S E R V I C E N O T E

Agilent Medalist i3070 In-Circuit Test System

Changes to Control XTP card Firmware due to change in old NEC 4Mx4bit SRAM to new NEC 2Mx8bit SRAM

Rev. 17

Figure 1: Diagnostics failure message when wrong firmware is loaded.

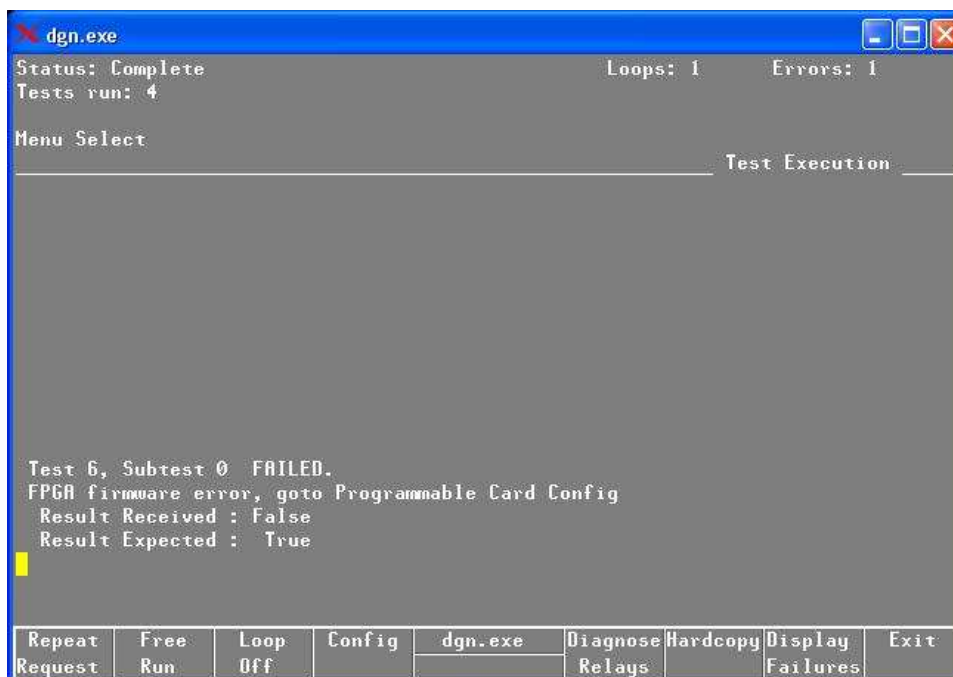
If the wrong firmware is loaded, the Control XTP card will not function correctly. Users who have testheads that installed with Control XTP of one version and software release of another version may detect this differences at failing diagnostics “Test 6, Subtest 0” with the error “FPGA firmware error”. This is a symptom that the firmware versions are different. (See Figure 1)

Figure 2: Control XTP card label (installed with old 1818-8683 NEC 4Mx4bit SRAM)

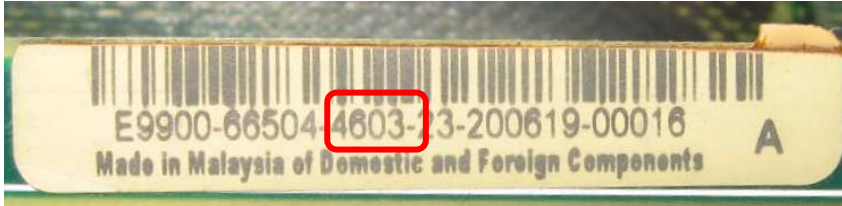
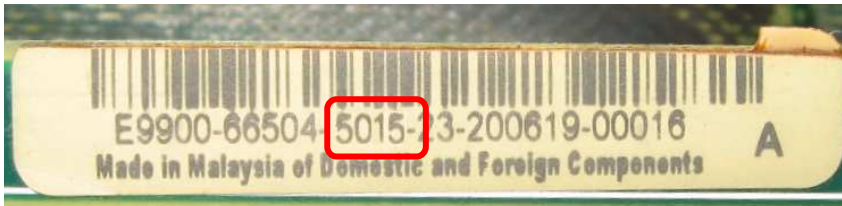
The boards installed with these new SRAM can be identified by a new code on the card label.

Control XTP cards	Label
Cards with NEC 4Mx4bit SRAM	E9900-66504- 4603 -23-xxxxx-xxxxx
Cards with NEC 2Mx8bit SRAM	E9900-66504- 5015 -23-xxxxx-xxxxx

Figure 4: Location of NEC SRAM on the Control XTP Card

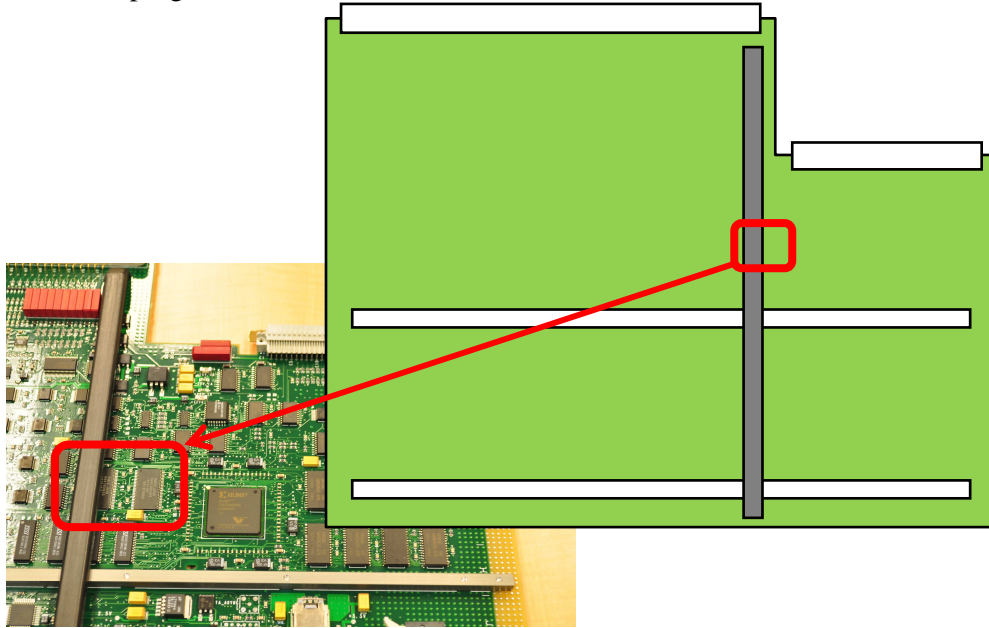
Another way to identify the different SRAMs is from the markings on the IC. The SRAMs can be found near the top right corner of the Control XTP card.

Figure 6: Diagnostics Configuration to update firmware

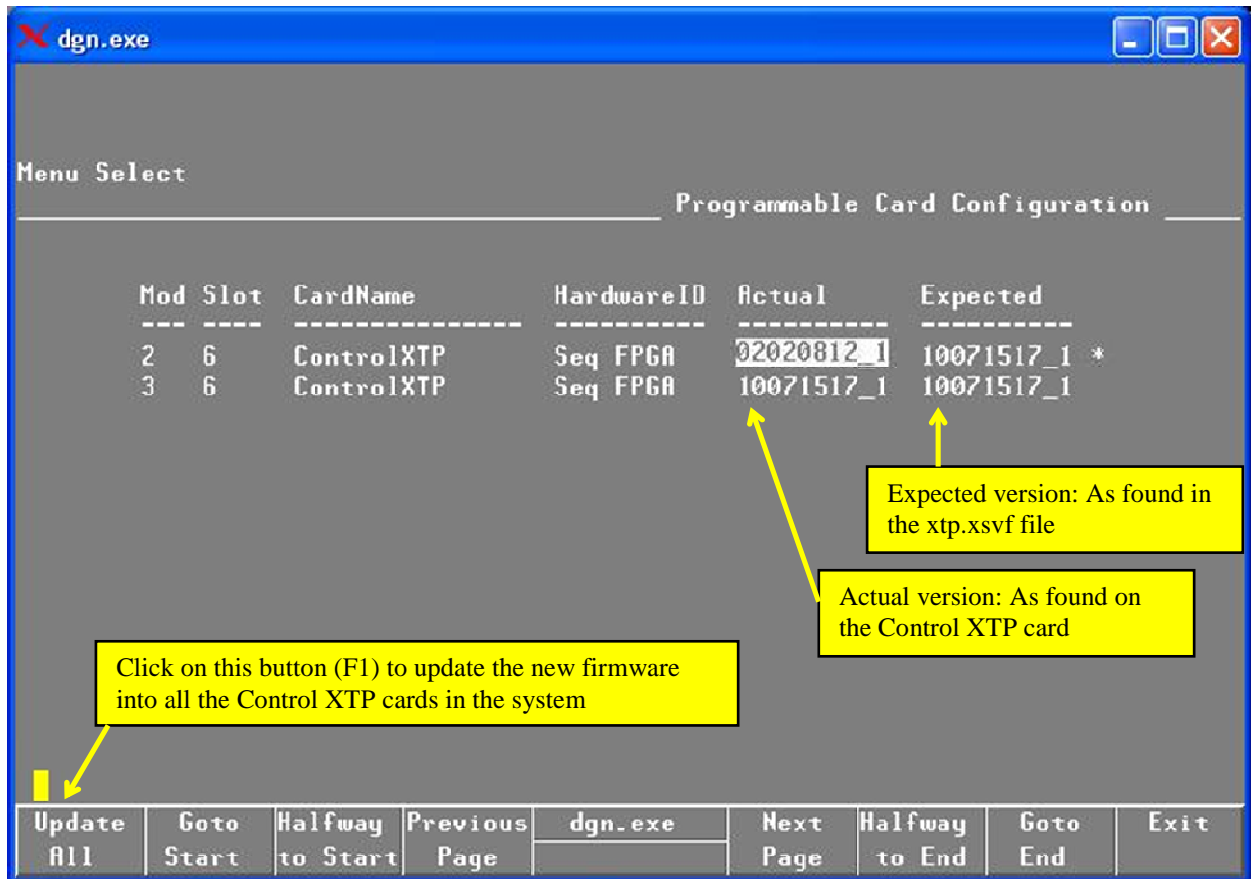
- a. Boot up the testhead as described above
- b. Launch the diagnostics application
- c. Click on “Configuration” and click on “Programmable Card Config”
- d. Click on “Update All” (F1) button to program all the Control XTP cards on the testhead.
(Note: Please ensure that the expected value should be **10071517_1** before updating)
